RECORD DRAWING
MHB SEPT '00

Lots 1 & 2 Ridge Plaza 11th Add.
PRIVATE STORM WATER SEWER
Project No. 97 1PPS (60786)

DBL FACE TYPE I CURB INLET
OPNG = 2 @ 6"x5'-0"

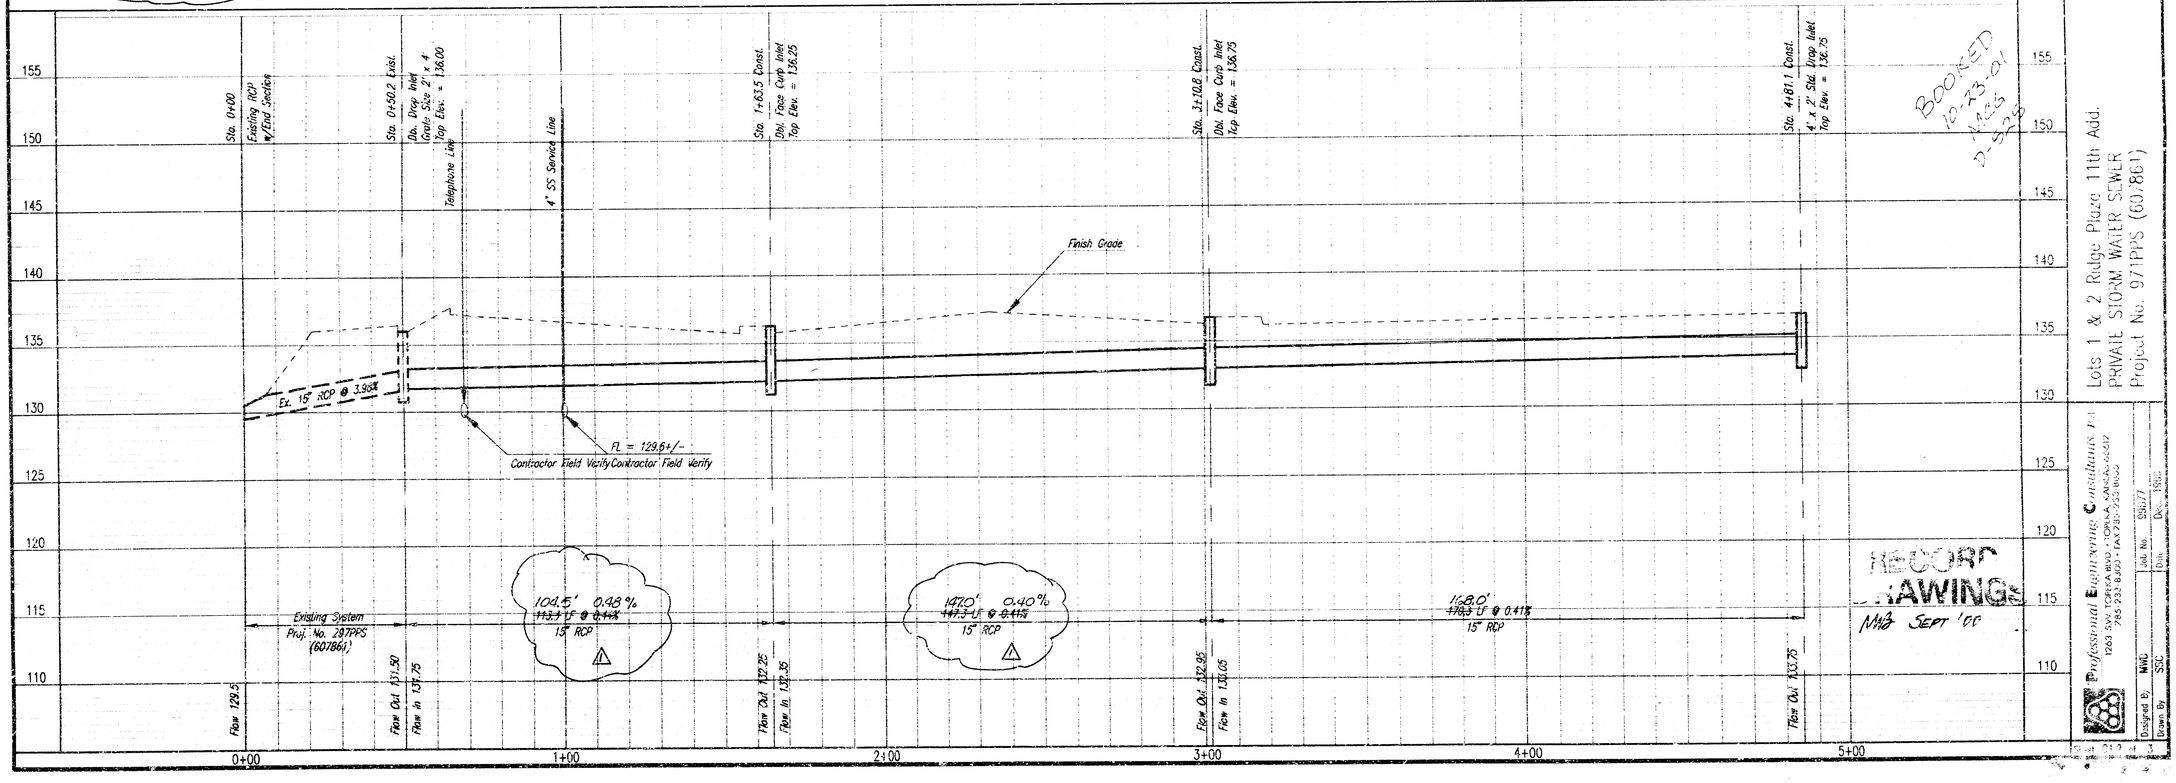
Sta. 1+63.5 Construct
Dbl. Face Curb Inlet (Type I)
L=8'-4" W=3'-7"
Top Elev. = 136.25
147.0' Instl. ~~147.3~~ LF 15" RCP (NE)
Connect roof drains
NOTE: Inlet Moved 2' South.

Sta. 0+50.2 Exist.
Dbl. Dbl. Drop Inlet
Grate Size 2' x 4'
Top Elev. = 136.00
Modify opening to receive new roof drains (N)
Retain existing roof drain(s).
~~Install 113.3 LF 15" RCP (NW)~~
NOTE: Install 104.5' LF 15" RCP (NW)

Sta. 3+10.8 Construct
Dbl. Face Curb Inlet (Type I)
L=6'-4" W=3'-7"
Top Elev. = 136.75
~~Install 170.3 LF 15" RCP (E)~~
NOTE: Install 168.0' L.F. 15" RCP
